MONUMENT RIDGE EAST FILING NO. 1
WATER, SANITARY SEWER, AND SANITARY SEWER FORCE MAIN
PLAN & PROFILES
EL PASO COUNTY, COLORADO

UTILITY CONSTRUCTION DRAWINGS

STA: 1+00 ~ 3+60

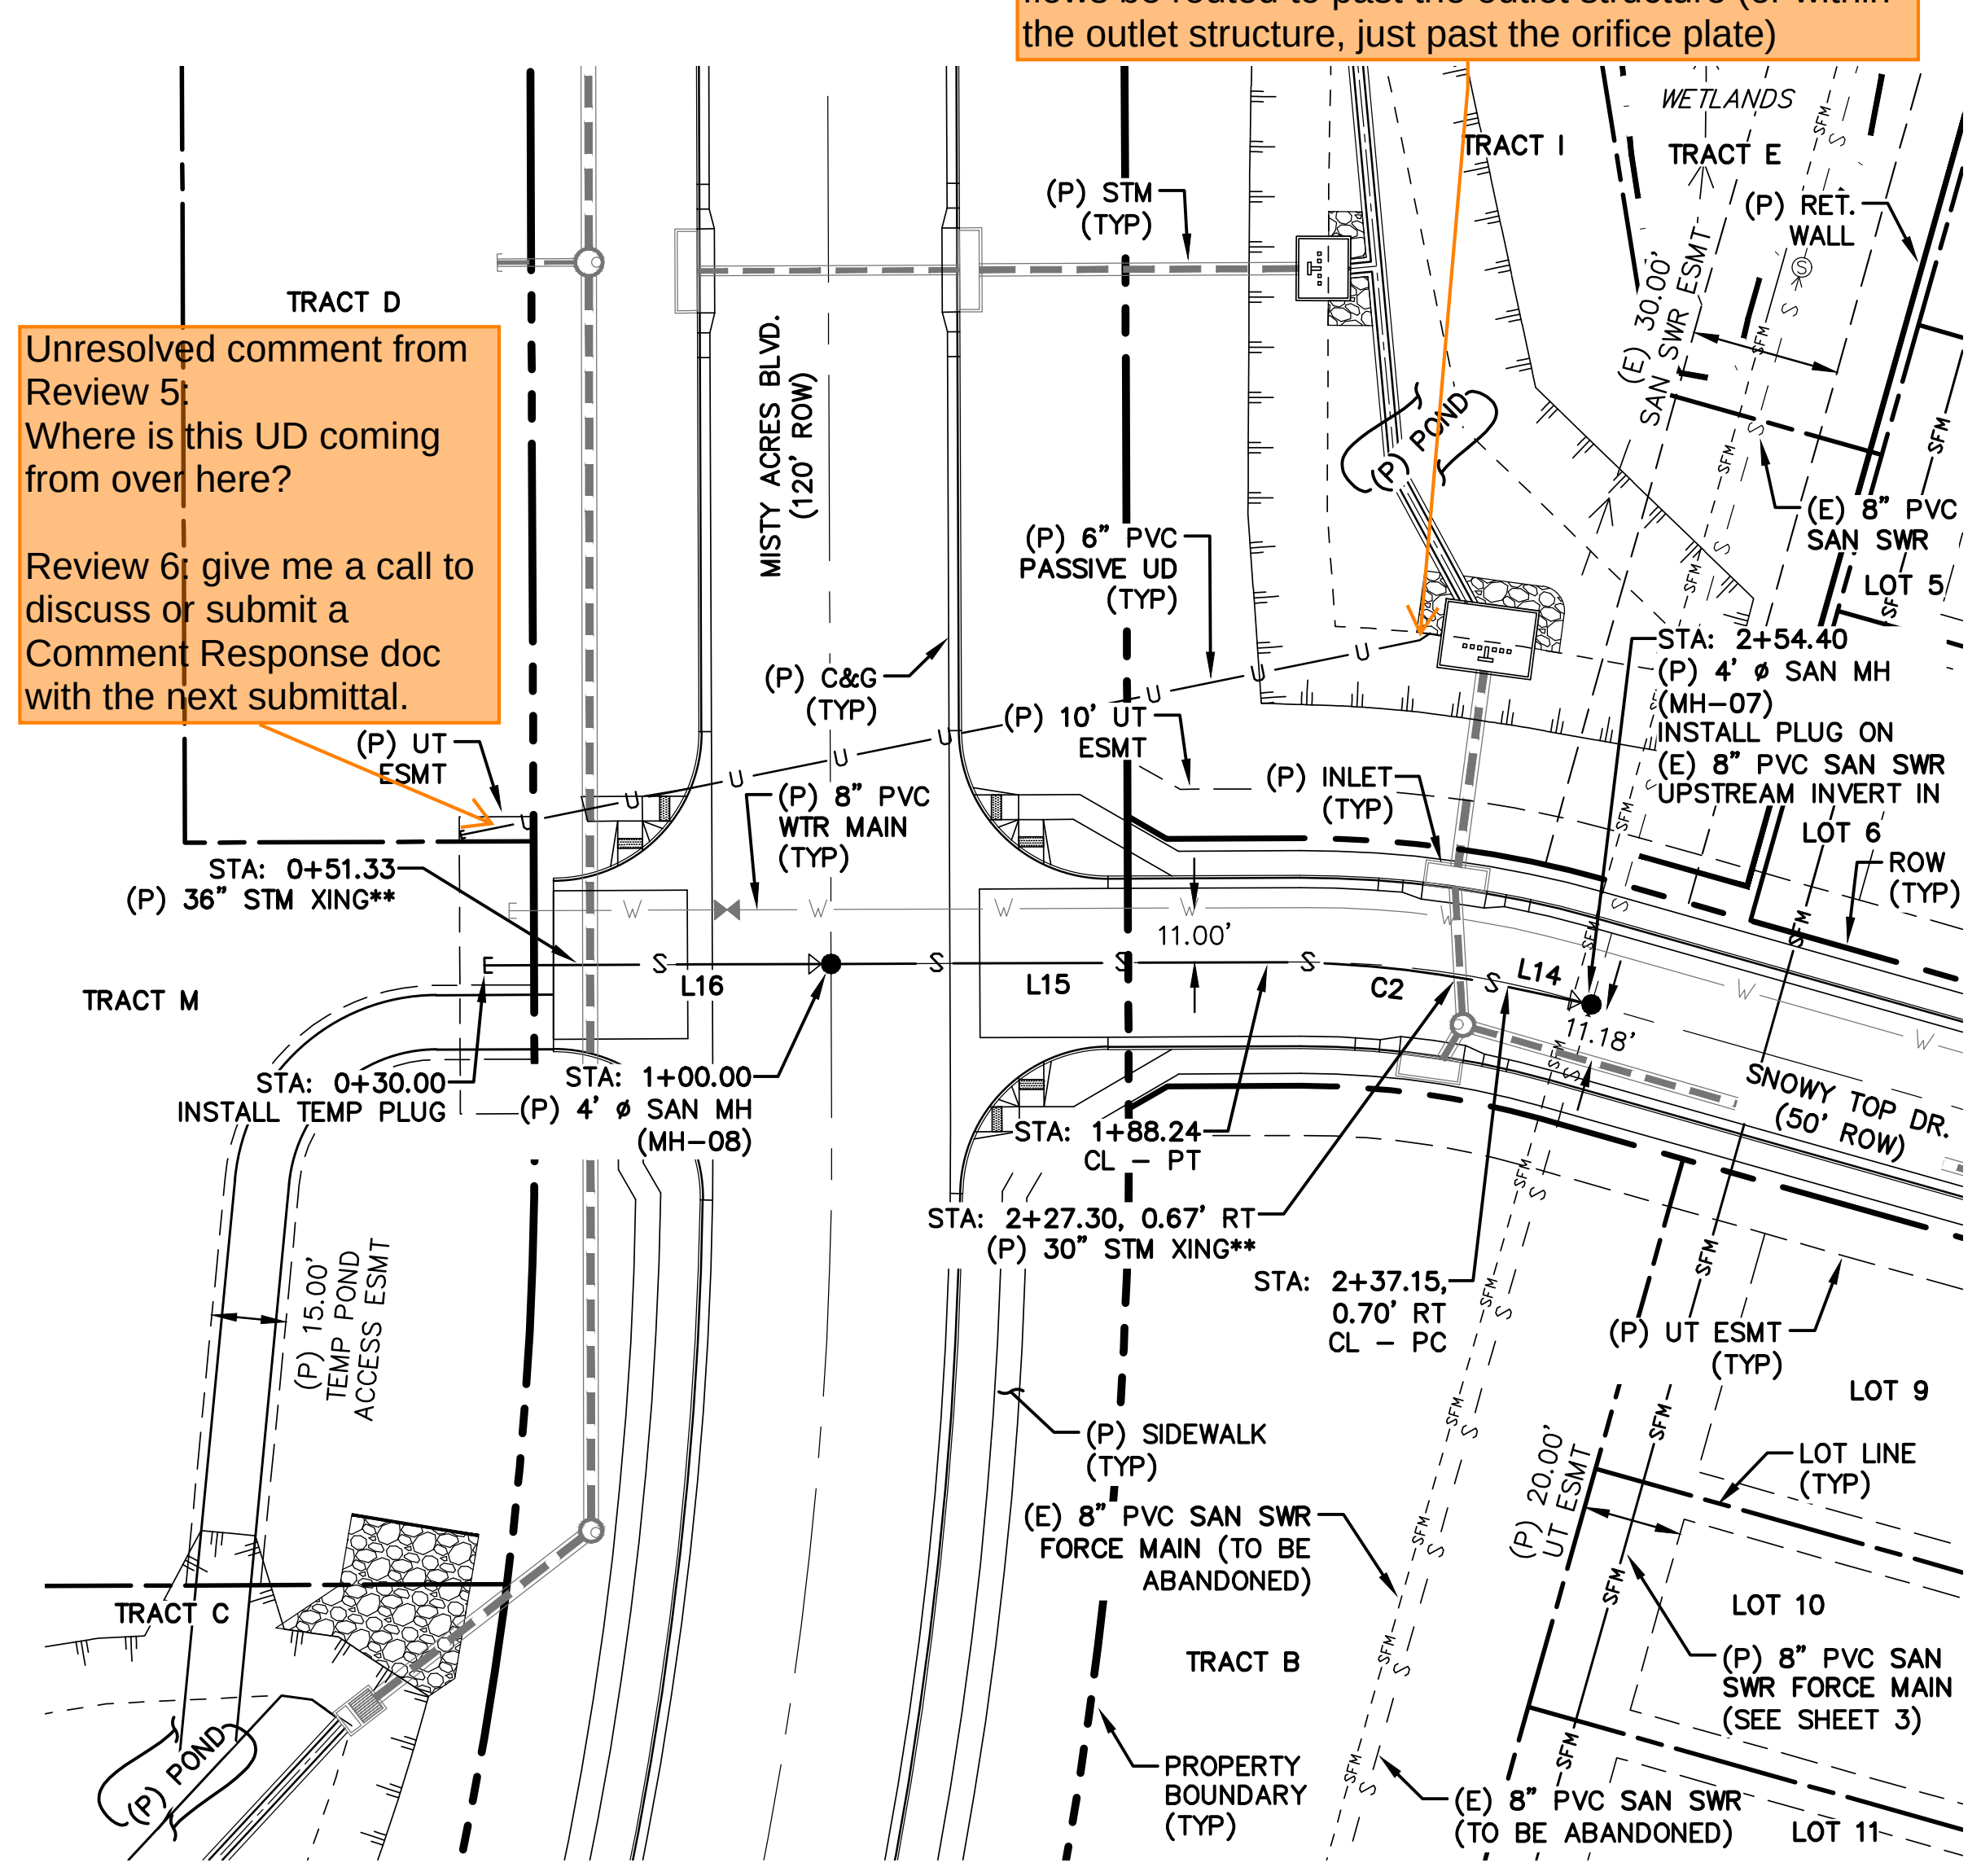
Unresolved comment from Review 5:
The pond has not been sized for the flows from this underdrain. MHFD recommends all GW/underdrain flows be routed to past the outlet structure (or within the outlet structure, just past the orifice plate)

Unresolved comment from Review 5:
Where is this UD coming from over here?

Review 6: give me a call to discuss or submit a Comment Response doc with the next submittal.

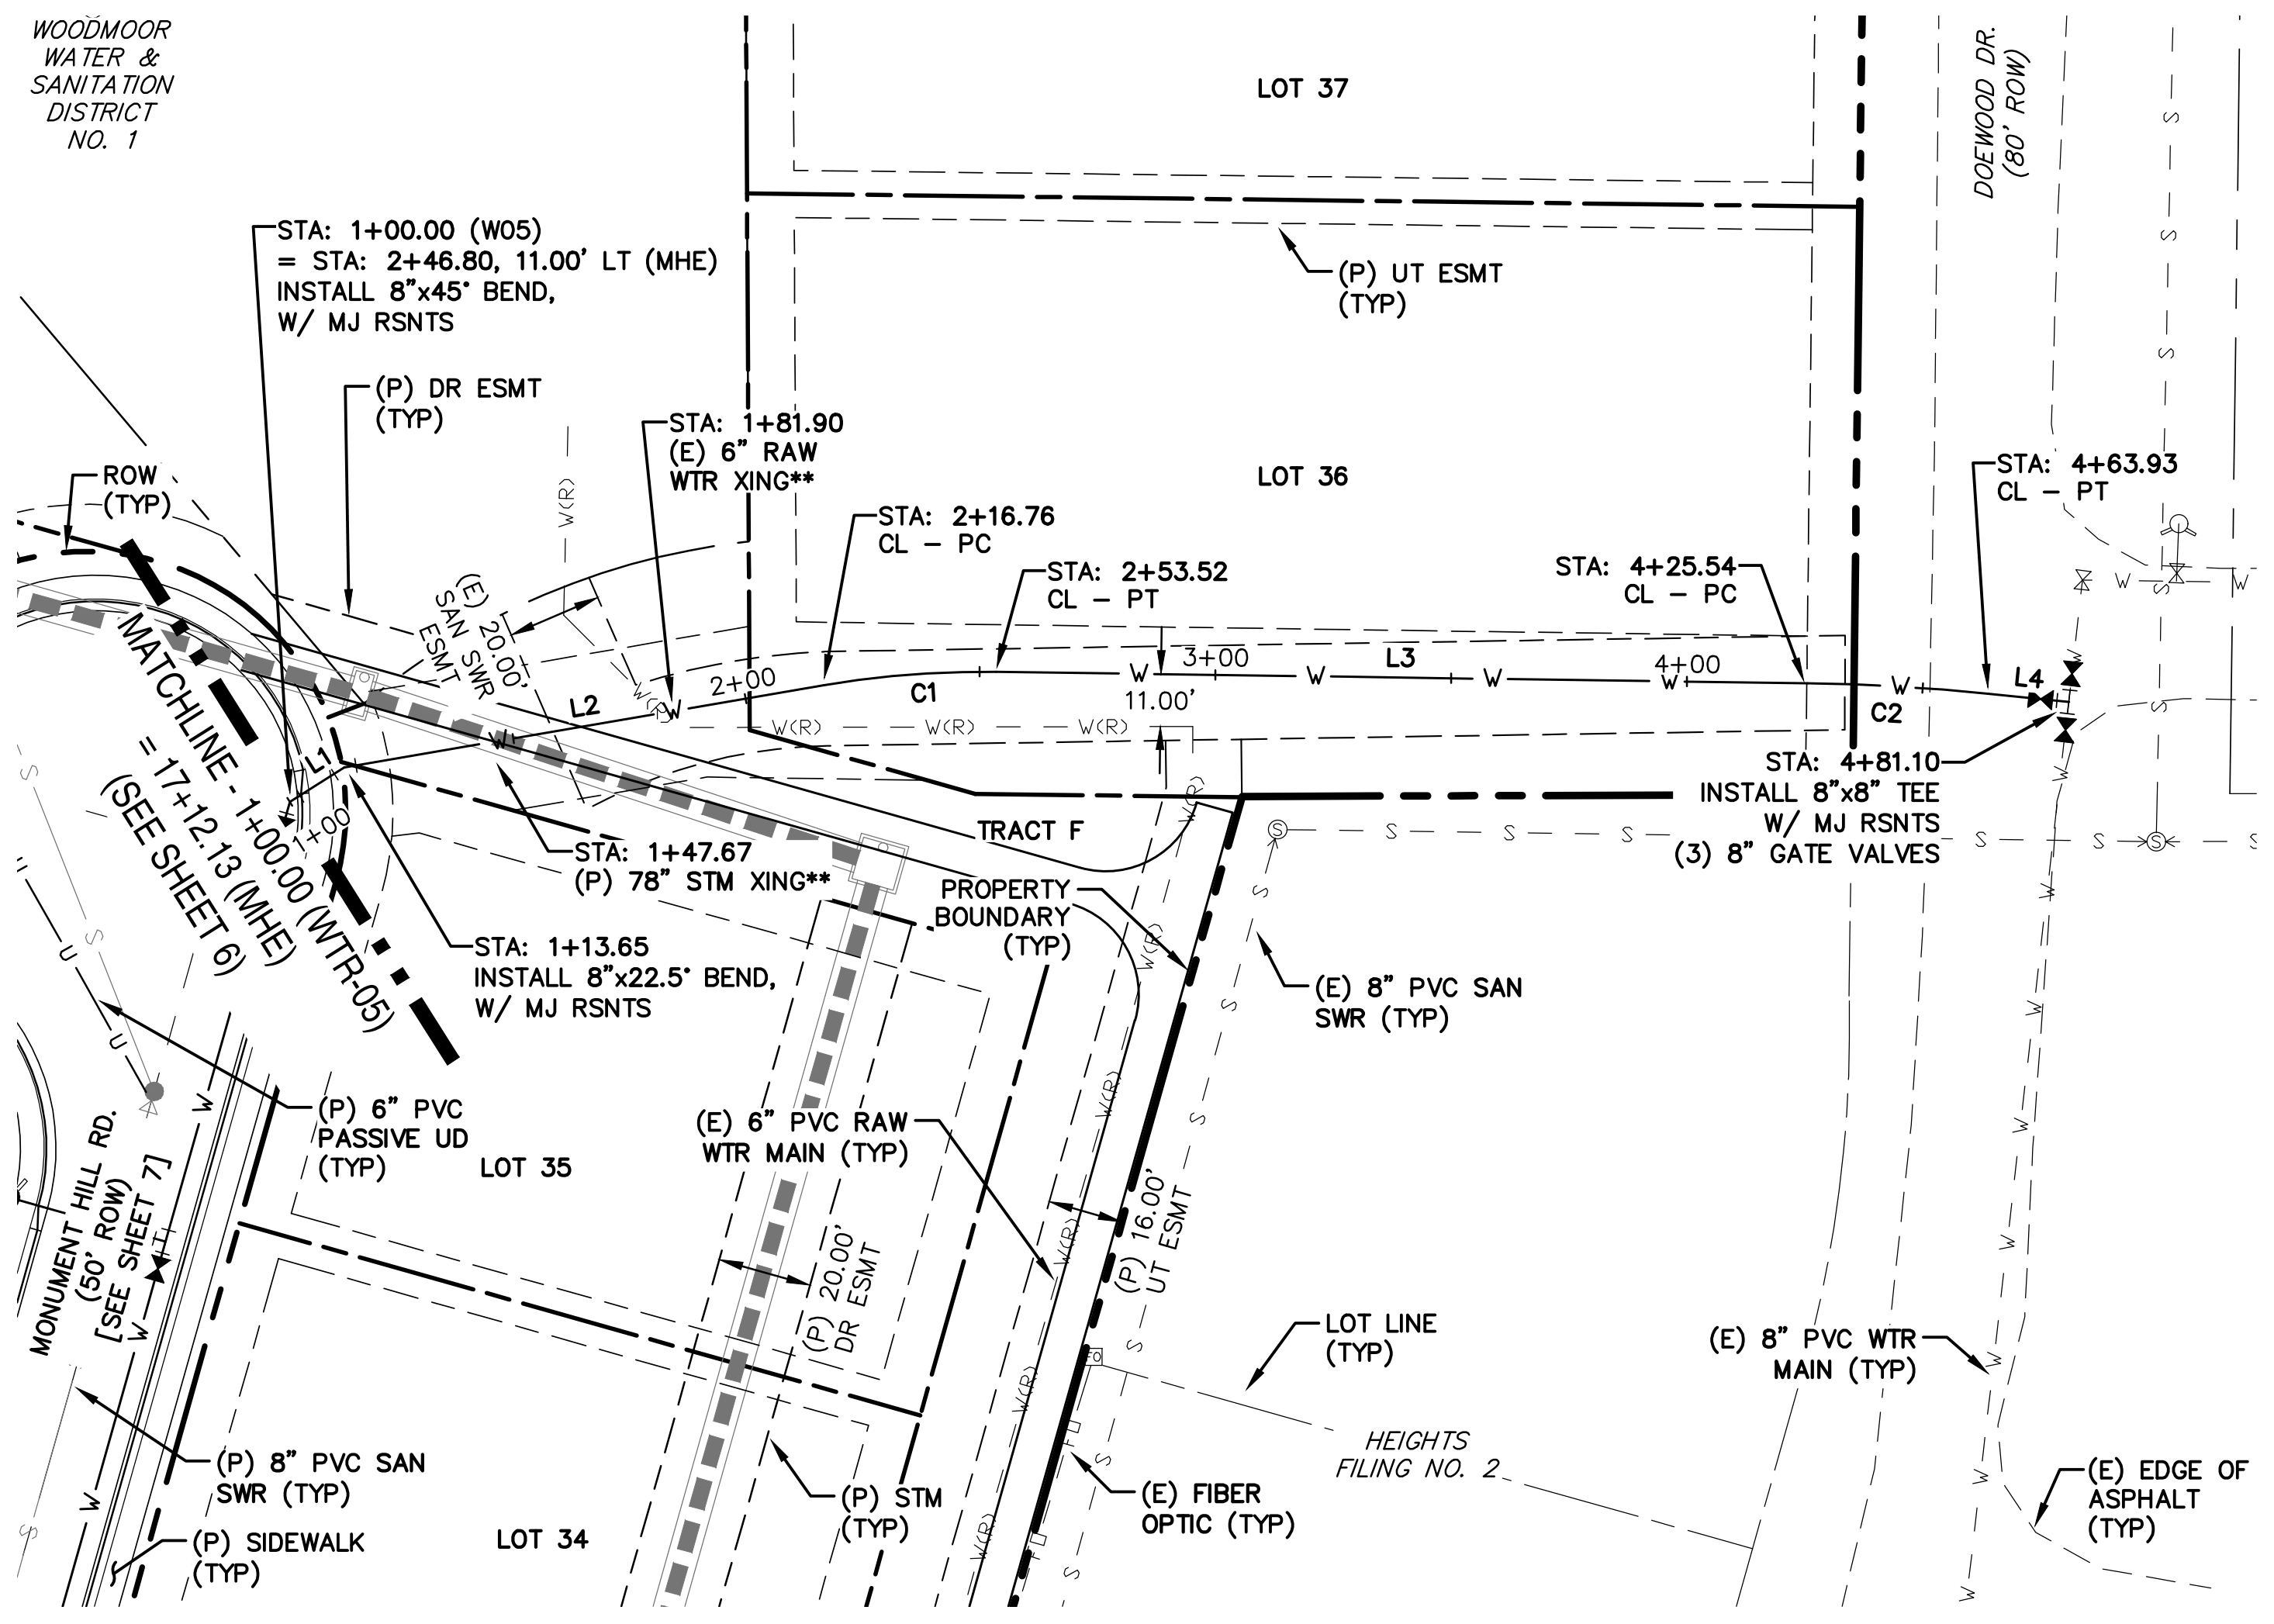
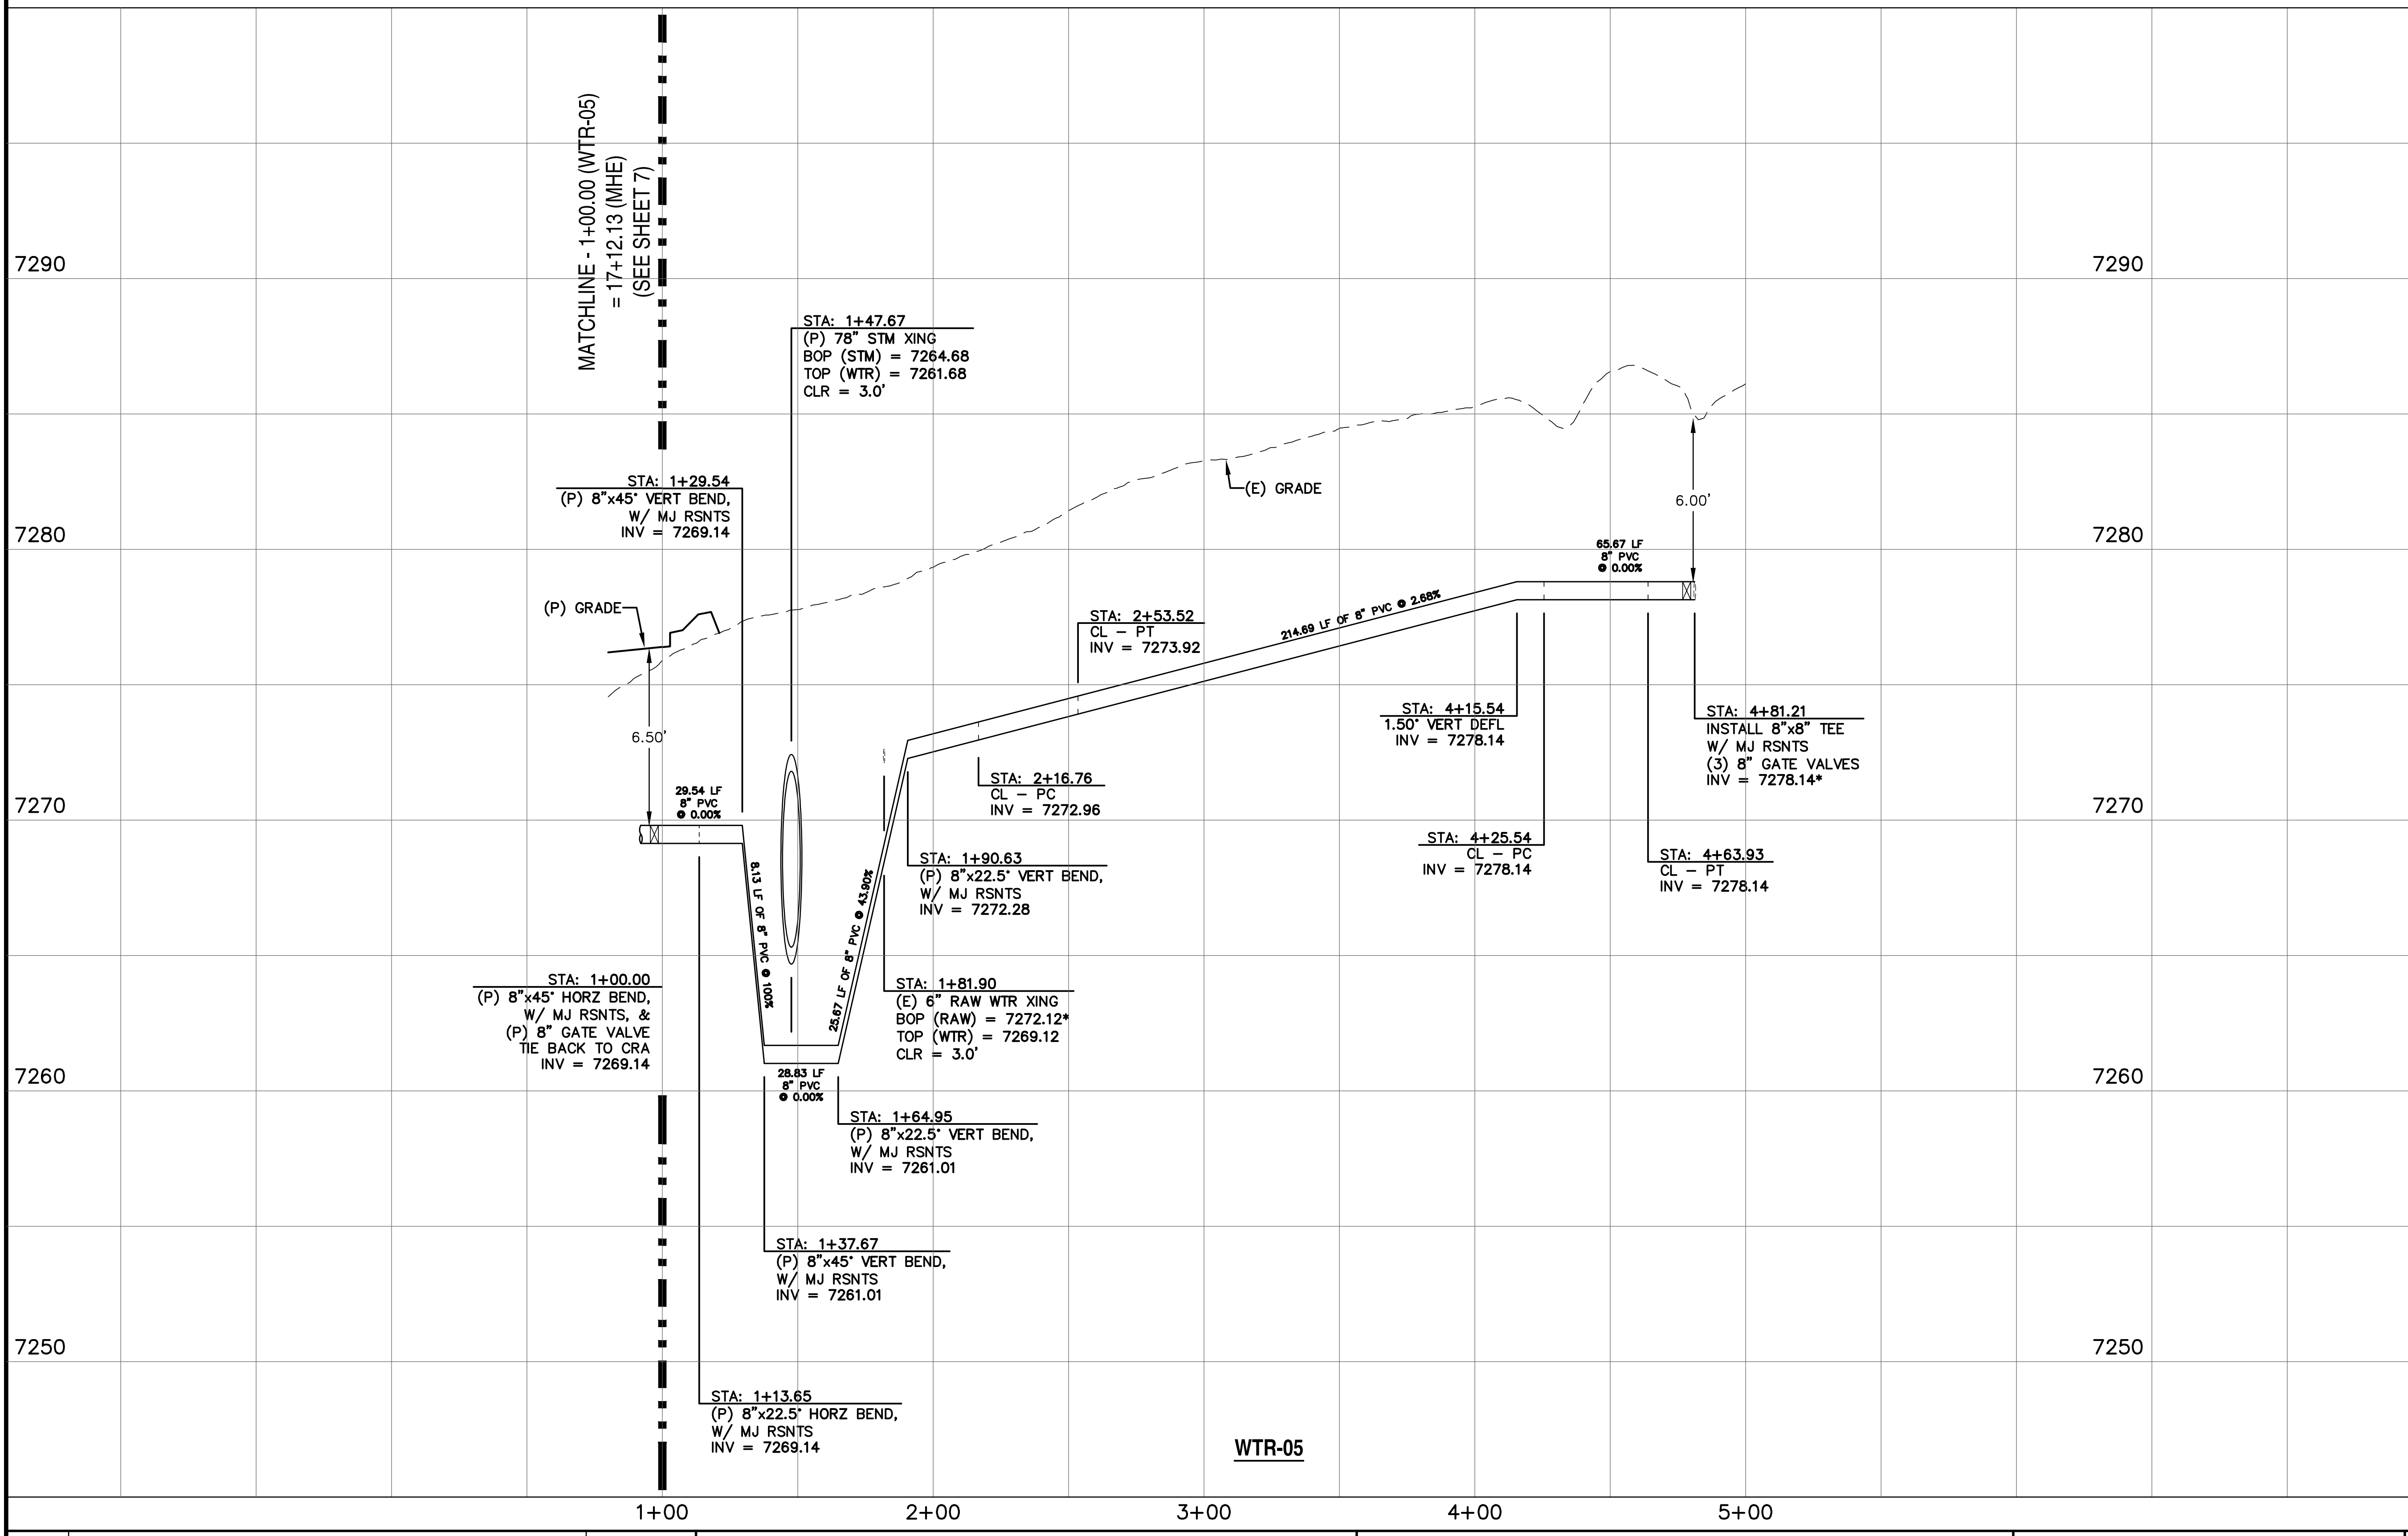
Unresolved comment from Review 5: same comments/questions about the UD as on page 4 above (since this is the same pipe/pond)
